Office Action Summary	Application No. 10/529,103	Applicant(s) FELDHAUS ET AL.	
	Examiner Rodney H. Bonck	Art Unit 3681

DETAILED ACTION

The following is a first action on the merits of application Serial No.10/529,103, filed March 24, 2005.

Fig. 1

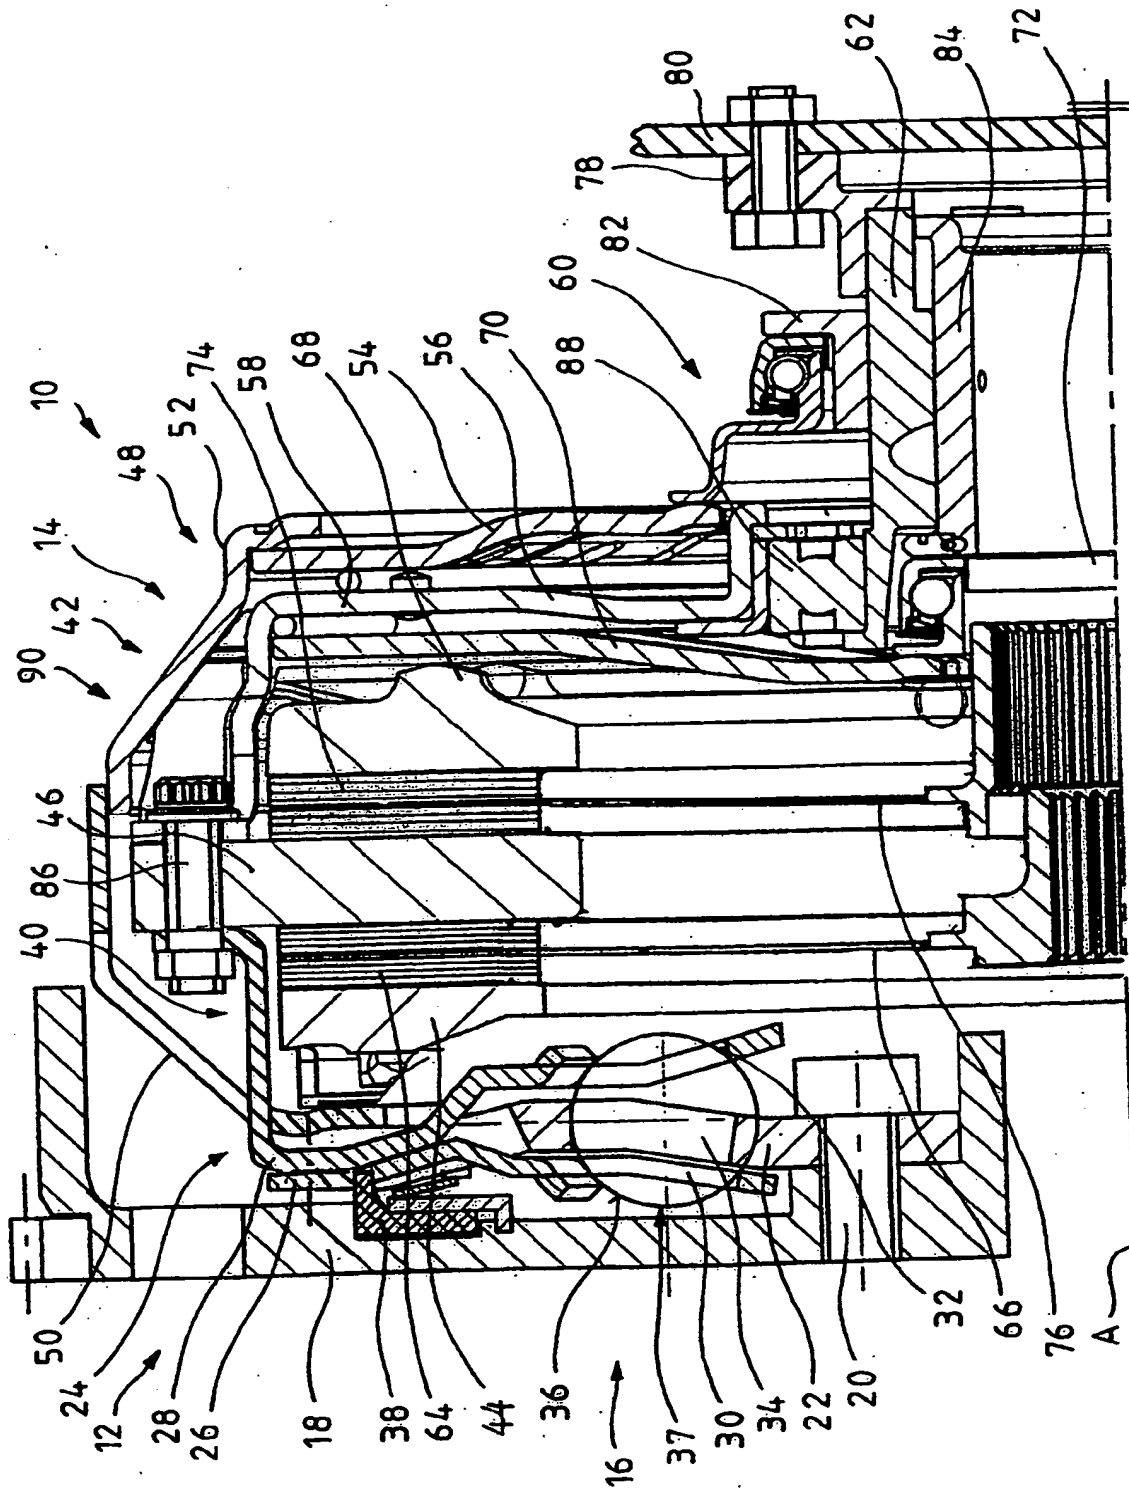
The replacement sheets of drawings were received on March 24, 2005. These drawings are approved.
